ERECTION FRAMING PLAN
(SHIPMENT 3)

SHOP DRAWING REVIEW

ERECTION FRAMING PLAN
VT 78 OVER MISSISSQUOI BAY, BRIDGE NO. 2
VT 78 STA. 10+970.425 TO STA. 12+059.775
TOWNS OF ALBURG AND SWANTON
COUNTIES OF GRAND ISLE AND FRANKLIN
STATE OF VERMONT, AGENCY OF TRANSPORTATION

CONTRACT NUMBER: VT-04057-3 DRAWING NUMBER: E7 OF E11

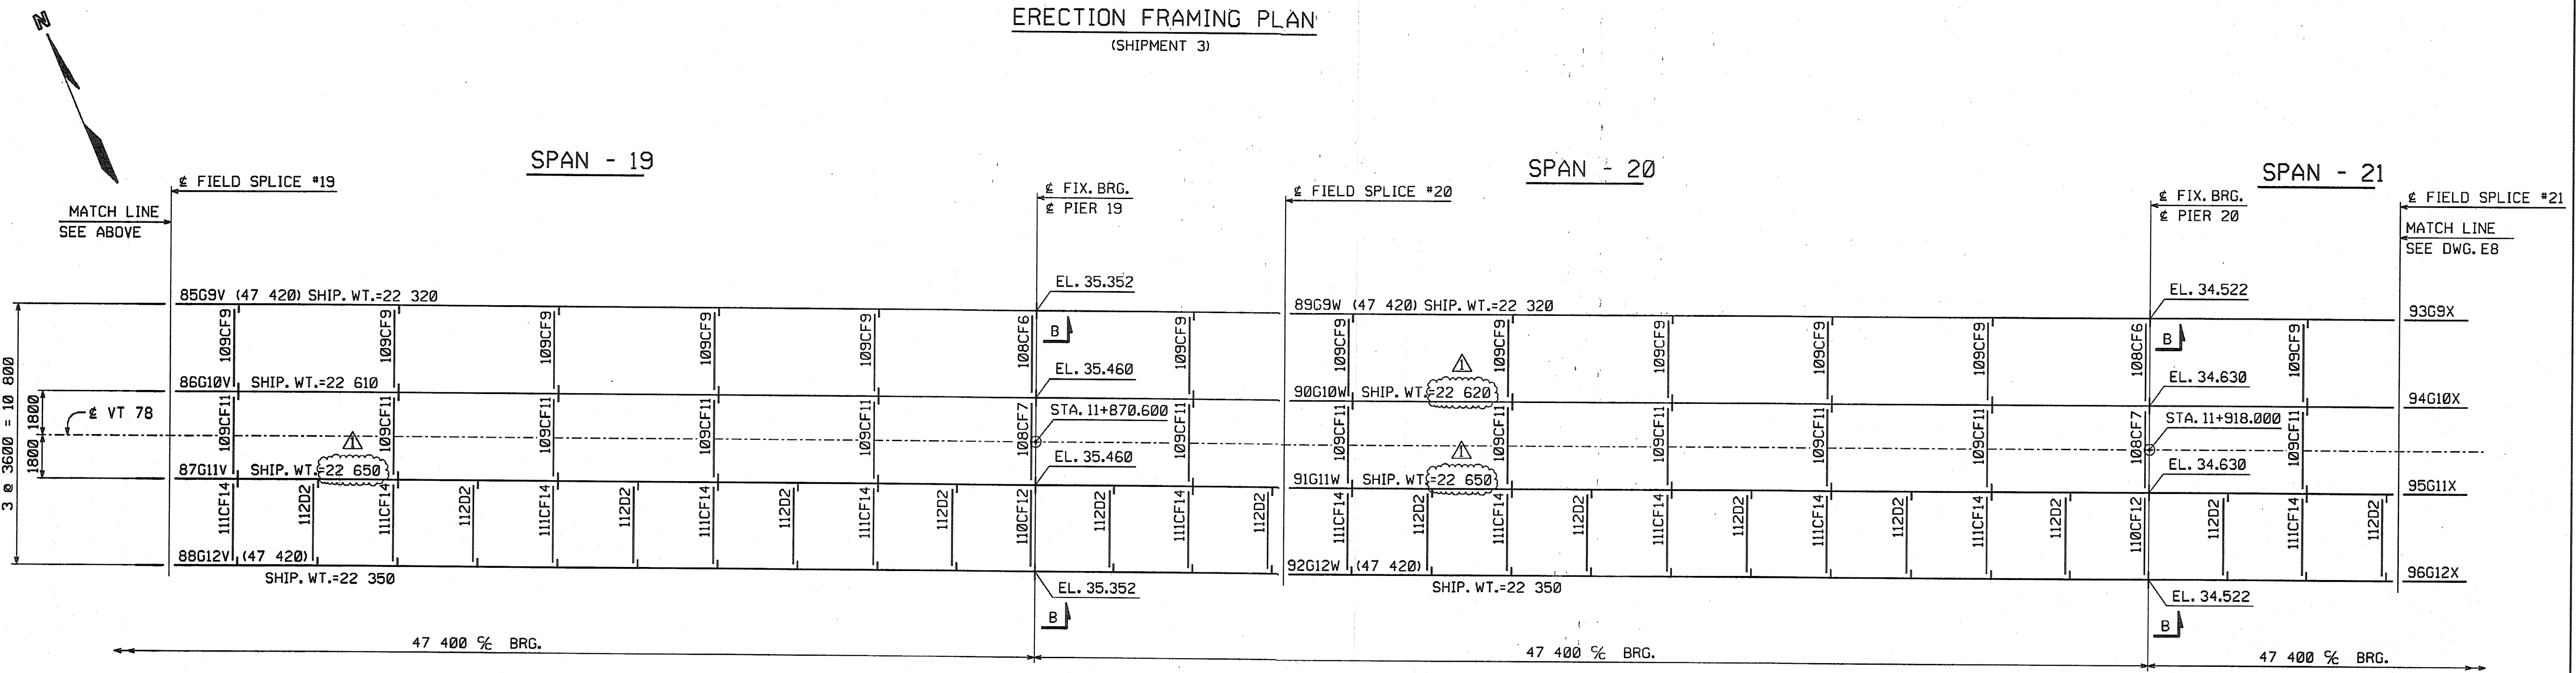
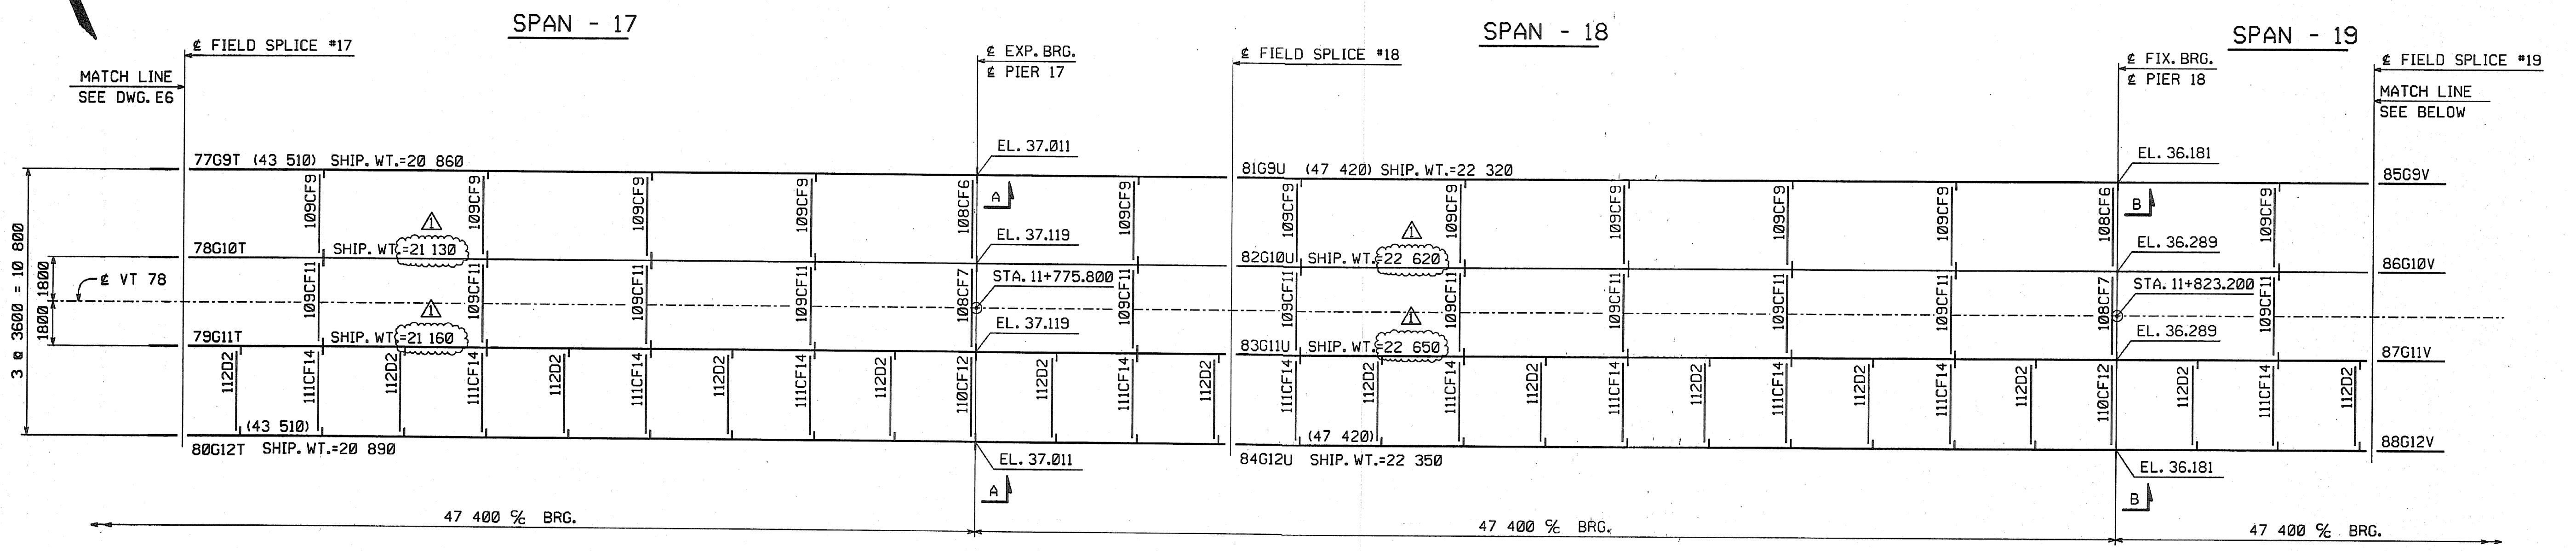
INCREASE LENGTHS TO SATISFY REQUIREMENTS FOR LENGTH & MEAN TEMPERATURE OF 45°F. (WEIGHT CHANGED) DP 9/20/04
